Title: Permit Number 2016-ARP-0040, Nor Wes Property  
Site Plan Review, Lake Forest Park, WA

Prepared For: Lee MacArthur  
Parcel #4022903193

Prepared By: Urban Forestry Services, Inc.  
Kurt Fickeisen  
Registered Consulting Arborist #472  
ISA Certified Arborist® #RM-451A  
ISA Tree Risk Assessment Qualified

Date: October 19, 2016

Figure-1: Current site plans with marked trees and proposed driveway location.

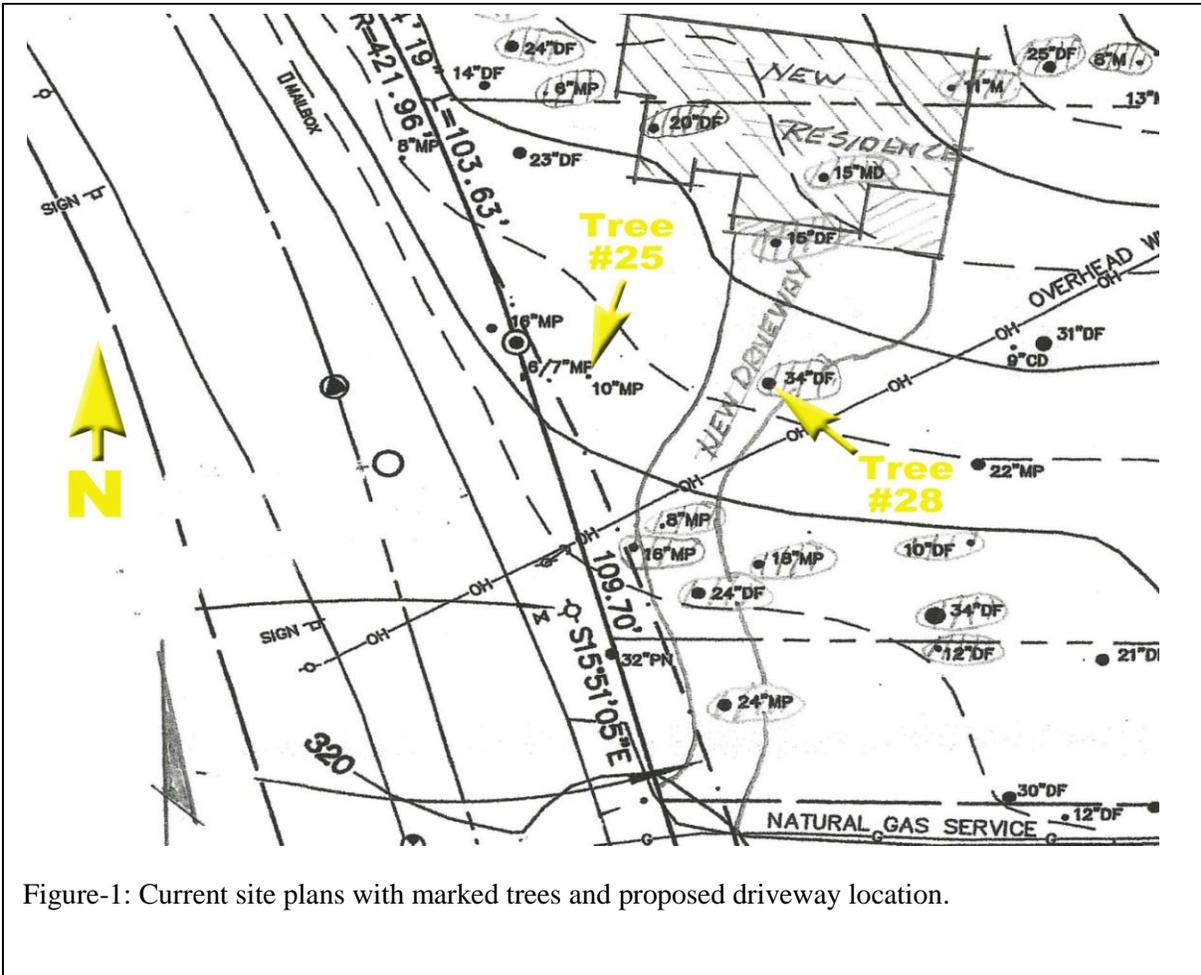
As requested by the City of Lake Forest Park Planning and Building Department, I reviewed construction plans at the Nor Wes property, parcel #4022903193, 190XX 195th St., Lake Forest Park, WA 98155. A proposed driveway would require removal of Tree # 28 (Figure-1). Modifications to the driveway footprint could preserve Tree #28.

Tree #28 is a 29-inch diameter Douglas fir (*Pseudotsuga menziesii*) (Photo-1). The tree is east of Tree #25, an 11-inch diameter big leaf maple (*Acer macrophyllum*) (Photo-2). Current plans call for removal of Tree #28 to provide space for the house driveway (Figure-1).

Based on a review of driveway requirements, preserving Tree #25 would require driveway placement to be located 5-feet from the trunk of Tree #28. The root flares of Tree #28

indicate that large structural roots grow south and northwest of the trunk. Root flare patterns do not indicate roots grow west of the trunk. The tree has a 10-foot radial crown spread, which suggests roots may occupy this area of soil.

While both Tree #25 and #28 appear in good condition at this time, the Douglas fir has a longer life expectancy than the big leaf maple does. In addition, there are other big leaf maples on the property are directly west of Tree #25.

Due to questions regarding root growth west of Douglas fir #28, **hand excavation** to a depth of 2-feet west of the tree should be done to locate and expose significant structural roots. Excavation should be no closer than 7-feet from the trunk because this area is within the Critical Root Zone (see attached Critical Root Zone Explanation).

An arborist should be present during this excavation to confirm the lack of significant structural roots. The arborist can facilitate excavation with an Air Knife or similar device which allows excavation to take place with minimal impact to retained roots.

If no roots greater than 2-inches in diameter are exposed, the eastern edge of the driveway can be placed in this location west of Tree #28. The northern edge of the driveway can be placed 10-feet from the trunk.

If preserving Tree #28 is possible, Tree #25 should be removed due to risks of significant structural root damage during driveway installation.

If preservation of Tree #28 is possible, protection fencing should be installed prior to driveway and site construction. See the General Tree Protection Guidelines attached to this report.
